27 June 2019

**Concept Stage 1 State Significant Development - 301 and 305 Kent Street Concept Hotel Development (SSD 9694)**

**Figure 1:** Non-compliance with maximum 80m height control (proposed building envelope north (Erskine Street) elevation – image source: Architectus)

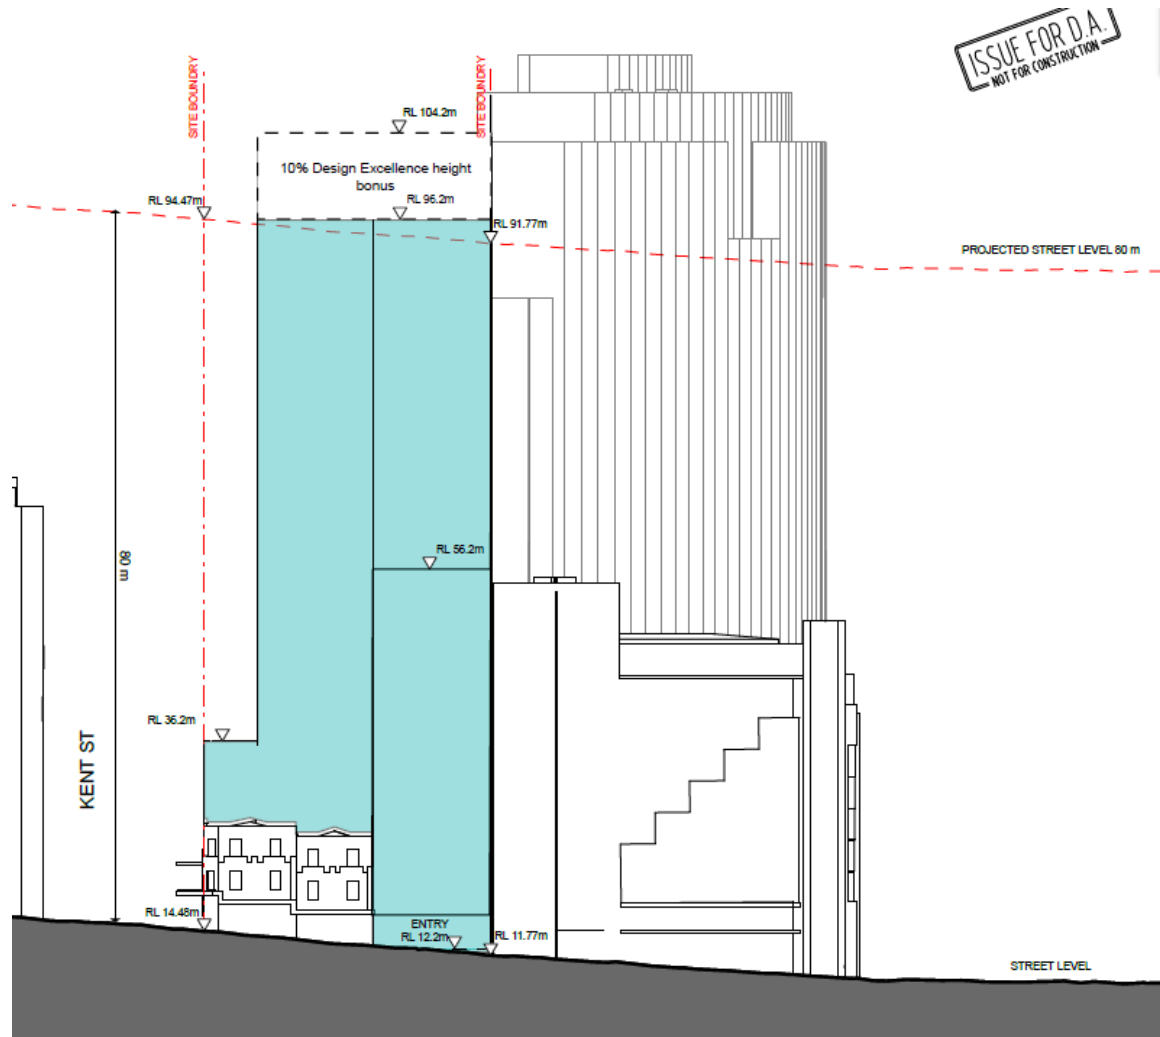
The concept envelope proposes a height of 84.5m which exceeds the maximum permissible LEP height of 80m by 4.5m (5.6% variation to control). This is largely the result of striking a horizontal plane at the top of the envelope rather than responding to the sloping topography of the site (refer image below).

The concept envelope shows that the additional height is proposed to be located above the maximum LEP height of 80m. This would result in a building that exceeds the maximum permissible height by 15.6%. This is not supported as it is not in accordance with the Sydney LEP. Clause 6.21(7)(a) of the LEP sets out that a building demonstrating design excellence:

The proposal should firstly be amended to comply with the maximum permissible height of 80m across the development site and conditions imposed clarifying that any additional height pursued through a competitive design process and the subject of a Stage 2 SSD is limited to an additional 10% of the height shown on the LEP map, in accordance with the LEP.
